MILLSTONE NUCLEAR POWER STATION, UNIT NO. 1

AMENDMENT TO PROVISIONAL OPERATING LICENSE

Amendment No. 38
License No. DPR-21

MILLSTONE NUCLEAR POWER STATION, UNIT NO. 2

Figure 6.2-1 Offsite Organization for Facility Management and Technical Support

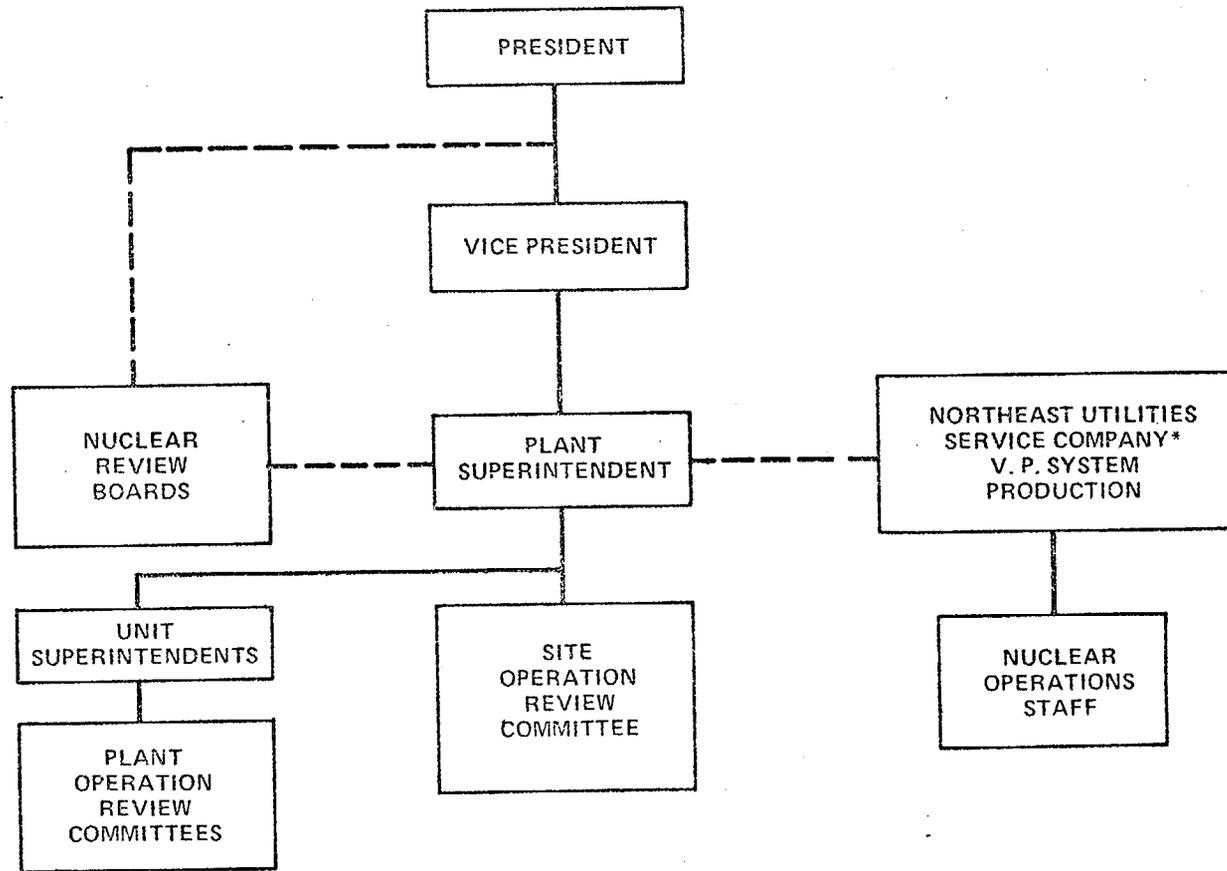
6.2.1 The offsite organization for facility management and technical support shall be as shown on Figure 6.2-1.

This change is also appropriately shown in the offsite organization detailed in Technical Specification 6.2.1 and is included for interactions with the PORC as specified in Technical Specifications 6.5.1.1 and 6.5.1.7. We find the changes to Technical Specifications 6.2.1, 6.5.1.1 and 6.5.1.7 to be consistent with the delegation of responsibility to the Unit Superintendents and are therefore acceptable.

Figure 6.2-1 Offsite Organization for Facility Management and Technical Support

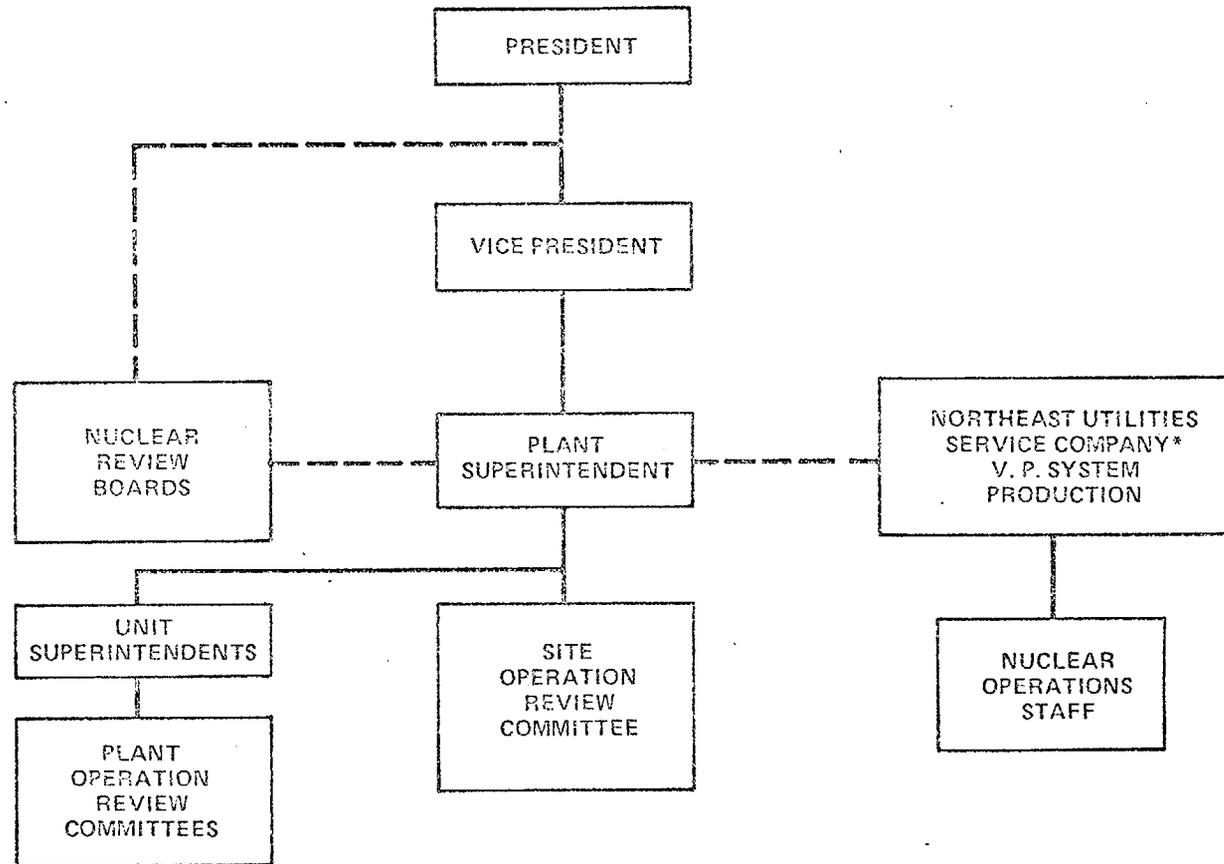
6.2.1 The offsite organization for facility management and technical support shall be as shown on Figure 6.2-1.
